Subject: **Docket Nos. 50-206, 50-361 and 50-362**
Annual Radioactive Effluent Release Report - 2015
San Onofre Nuclear Generating Station (SONGS), Units 1, 2, and 3

San Onofre Nuclear Generation Station
Annual Radioactive Effluent Release Report
2015
January – December

Annual Radioactive Effluent Release Report

SITE BOUNDARY FOR LIQUID EFFLUENTS
Figure 1-2

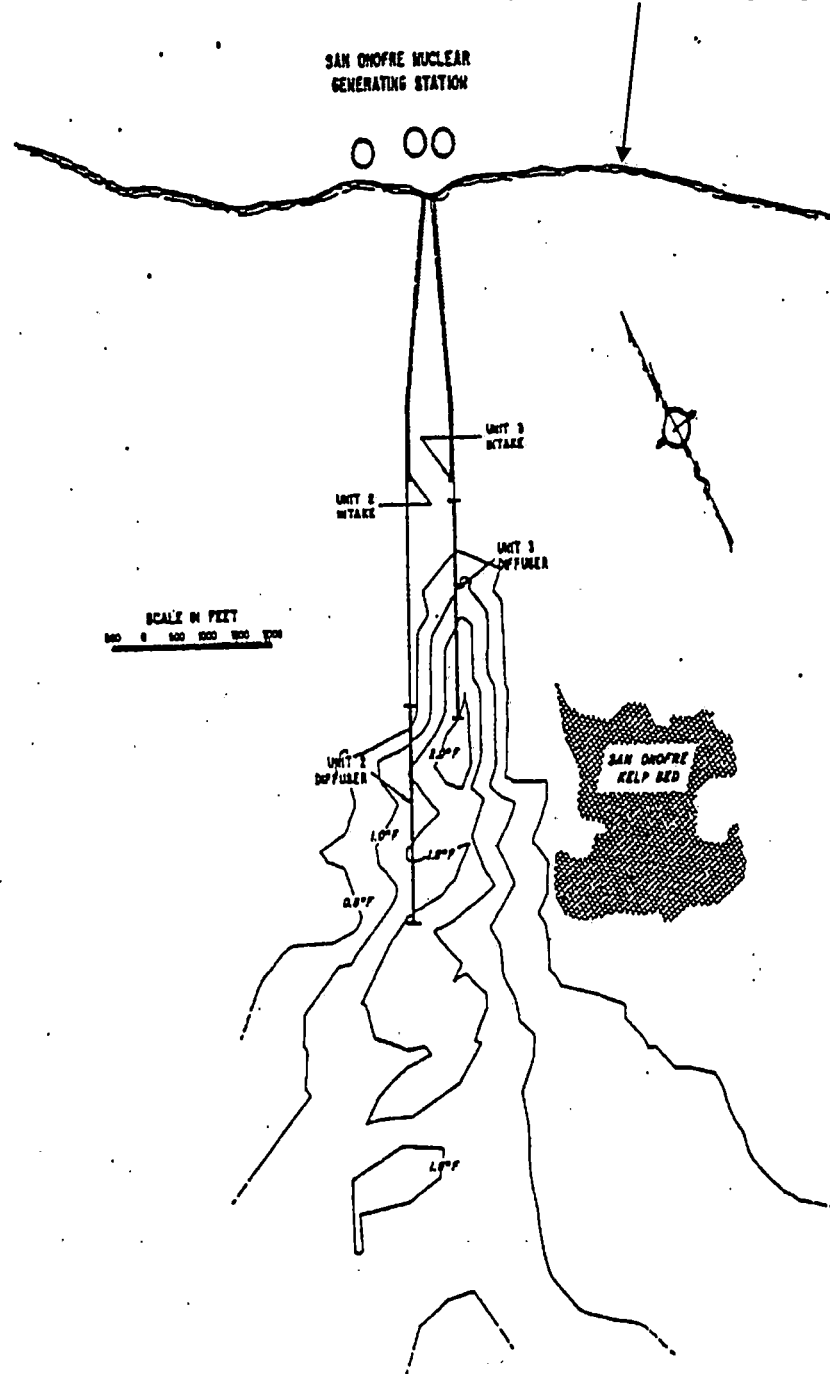
Page #	changes due to Revision	Reason
i-v	Update section titles and page numbers.	F
1-2	Remove batch and continuous release points of Radwaste Primary and Secondary Tanks, BPS Neutralization Sump, FFCD Sumps, Holdup Tank, CCW Sump, Storage Tank Area Sump, Auxiliary Building Sump; S/G Blowdown, S/G Blowdown Bypass Line and associated Footnotes. Add Footnote "g". Add Footnote "h".	D A A
1-3	Add Footnote "h".	A
1-5	Footnote h: added to clarify where liquid discharges may occur. Indicate Footnotes *, **, *** as DELETED.	A D
1-6	Remove Tech Specs and LCS that no longer exist.	D
1-7	Indicate liquid radwaste treatment system as portable. Revise Operational to Functional to match Tech Spec verbiage. Remove Tech Spec and LCS that no longer exist. Delete statements regarding plant Modes. Clarify processed liquids batch release.	R R D D R
1-8	Add site boundary clarification statement and line indicating boundary location.	A

Figure 2-2

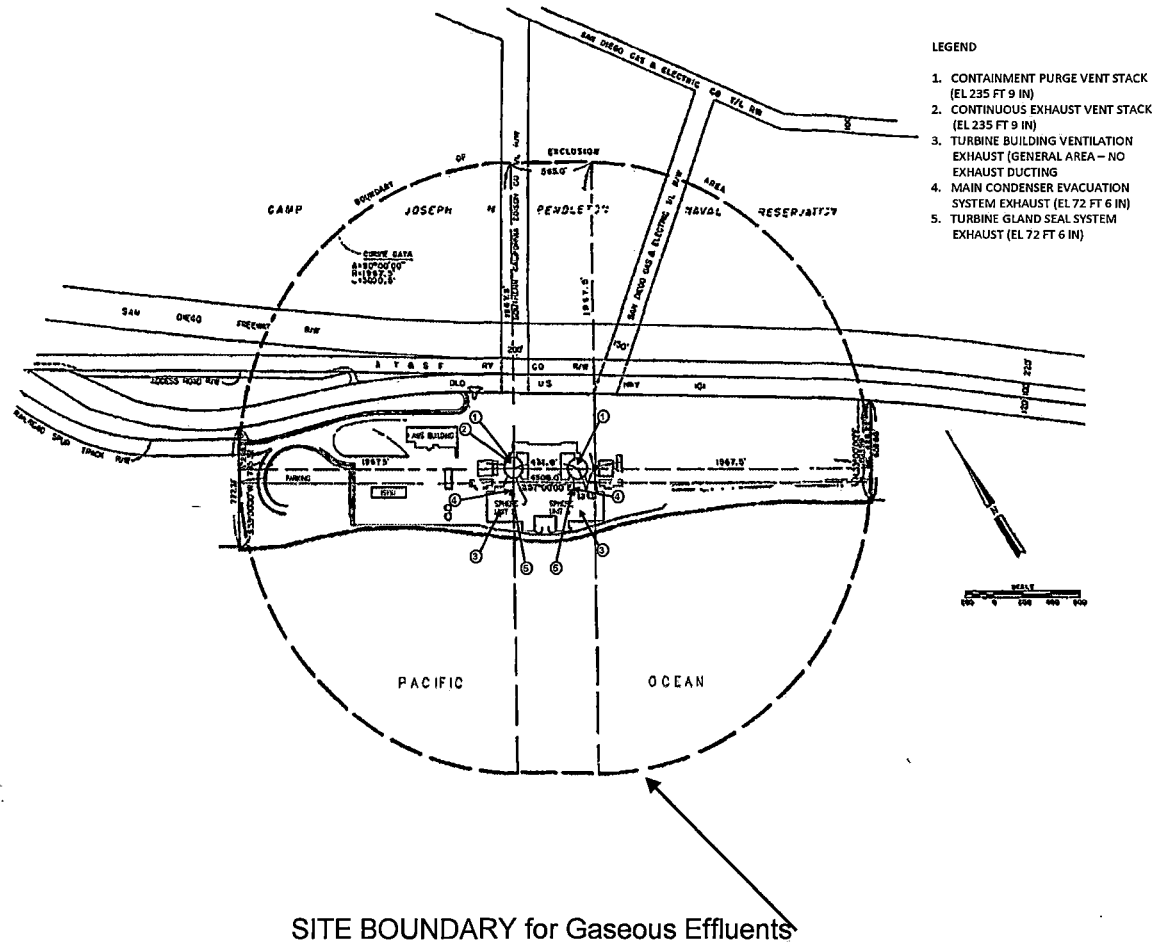
Indicate 2.4 Gaseous Radwaste Treatment as DELETED.	D
2-7	Identify site boundary line.	F
2-8	Remove no longer applicable release points. Update FLOC.	D F
2-9	Update FLOC. Clarify from where factor X/Q is obtained.	F R
2-10	Update FLOC.	F
2-11	Indicate 2.6.2 Condenser Evacuation System as DELETED. Deleted 2(3)RT-7828. Clarify that Containment Purge is Containment Mini-Purge. Delete NOTE regarding Containment Purge.	D D R D
2-12	Clarify that Containment Purge is Containment Mini-Purge. Deleted 2(3)RT-7828. Revise Flow rate factors. Delete Maximum Permissible Alarm Setting RT-7828. Indicate 2.6.4 Waste Gas Header as DELETED.	R D R D D
2-13	Indicate Table 2-3 as DELETED and remainder of page left blank.	D
2-14	Change Noble Gases to Noble Gas.	R
2-16	Change Noble Gases to Noble Gas. Clarify equation for ease of use.	R F
2-17	Clarify equation for ease of use. Correct grammar.	F F
2-18	Change number to word. Add parenthetical statement for Tables 2-7 and 2-8 location. Revise provider of Land Use Census.	F A R

SONGS RADIOACTIVE LIQUID WASTE EFFLUENT SYSTEMS
Figure 4-5

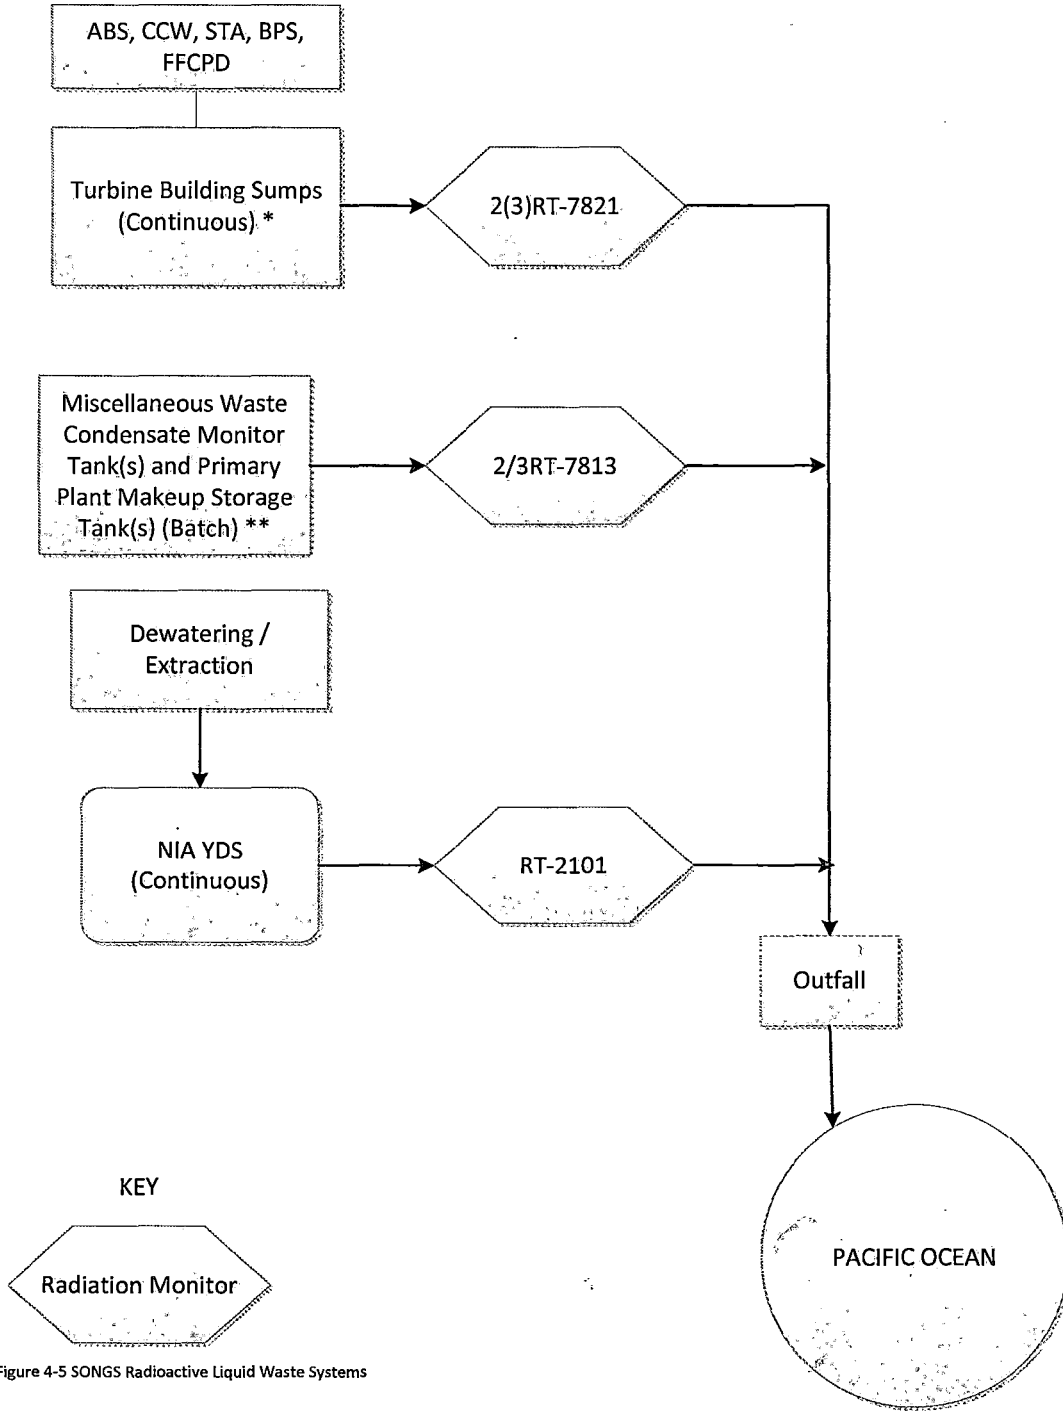
4-18	Revise Operational to Functional to match Tech Spec verbiage.	R
4-19	Clarify title of Figure and provide pathways to be used.	R
4-20	Clarify title of Figure and provide pathways to be used. Update FLOC.	R R
5-1	Delete LCS no longer in existence.	D
5-6	Correct Reg. Guide abbreviation and add revision number.	F
5-13	Change "reports" to "report".	F
5-15	Delete Footnote *** regarding PIC location. Clarify PIC location for future use.	D R
5-16	Delete Footnote *** regarding PIC location. Clarify PIC location for future use.	D R
5-17	Delete Footnote *** regarding PIC location.	F
5-18	Add new Footnote *** regarding the SONGS' garden. Update SONGS' garden distance. Correct typo.	A R F
5-20	Indicate Table 5-5 as DELETED and remainder of page left blank.	D
5-22 and 5-23	Revise location of environmental monitoring sample location.	R

SONGS RADIOACTIVE GASEOUS WASTE EFFLUENT SYSTEMS

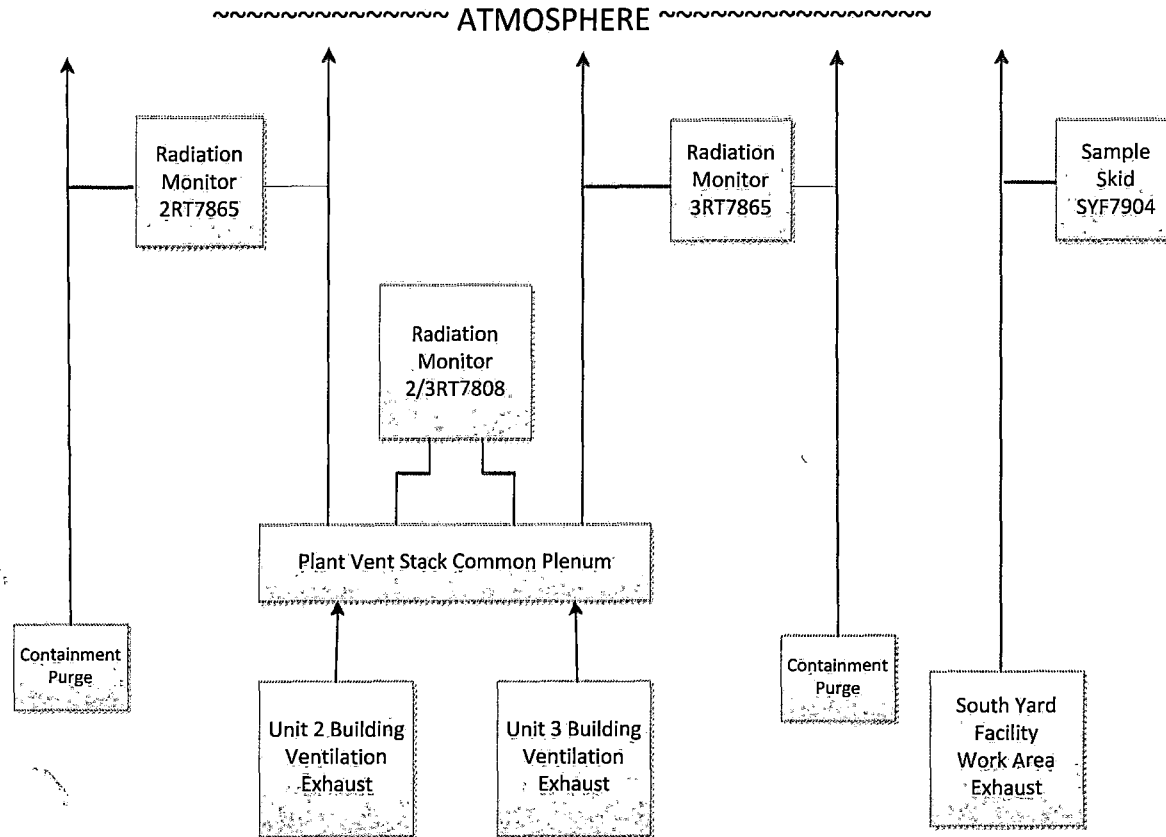
4-18	Revise Operational to Functional to match Tech Spec verbiage.	R
4-19	Clarify title of Figure and provide pathways to be used.	R
4-20	Clarify title of Figure and provide pathways to be used. Update FLOC.	R R
5-1	Delete LCS no longer in existence.	D
5-6	Correct Reg. Guide abbreviation and add revision number.	F
5-13	Change "reports" to "report".	F
5-15	Delete Footnote *** regarding PIC location. Clarify PIC location for future use.	D R
5-16	Delete Footnote *** regarding PIC location. Clarify PIC location for future use.	D R
5-17	Delete Footnote *** regarding PIC location.	F
5-18	Add new Footnote *** regarding the SONGS' garden. Update SONGS' garden distance. Correct typo.	A R F
5-20	Indicate Table 5-5 as DELETED and remainder of page left blank.	D
5-22 and 5-23	Revise location of environmental monitoring sample location.	R
6-1	Revise Operational to Functional to match Tech Spec verbiage.	R
6-2	Delete definition of Dose Equivalent I-131, Gaseous Radwaste Treatment System, and Mode. Revise Operational to Functional to match Tech Spec verbiage. Delete reference to Camp Mesa.	D R D
